# UNITED STATES PATENT AND TRADEMARK OFFICE

| APPLICATION NO. | FILING DATE | FIRST NAMED INVENTOR | ATTORNEY DOCKET NO. | CONFIRMATION NO. |
|-----------------|-------------|----------------------|---------------------|------------------|
| 09/806,304      | 03/29/2001  | Alain Brochez        | BROC3001/JEK        | 6723             |

## Office Action Summary

*Fig.2*

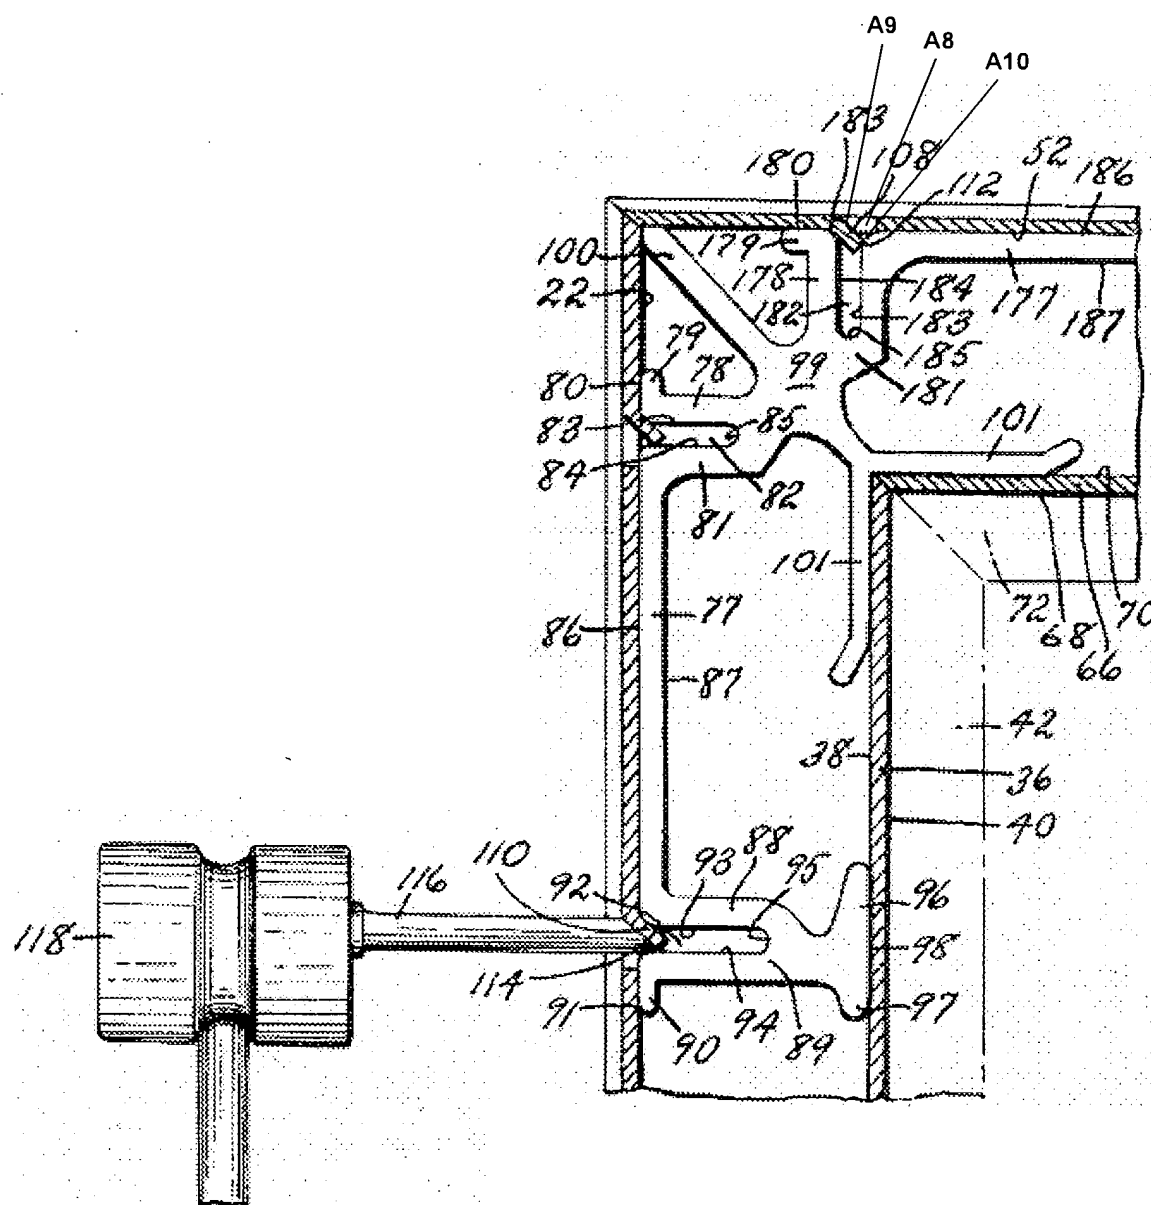
Regarding claim 33, Ekstein discloses, in Figure 2 and 3, a corner joint includes at least one corner piece **16** having two insert parts **74,75** joined at connecting ends **181** and positioned relative to one another at a predetermined angle. The corner piece **16** is provided with locking means **108** comprising lip projections **108**. The insert parts **74,75** each include at least one notch **A8** and a shape of a predominantly right-angle triangle **96**. The notch **A8** of each of the insert parts **74,75** comprises a triangular shape defined by one side **A9**, against which one of the lip projections **108** is positioned, is longer than another side **A10** over which a free end of the one of the lip projections **108** is pressed in. The lip projections **108** include a contact surface **112** disposed at one end thereof. The insert parts **74,75** includes at least one locking element **102** defining a contact surface configured geometrically. The locking element **102** has at least one characteristic, i.e., the at least one locking element **102** is only connected to the corner piece **16** at a base portion **178**.
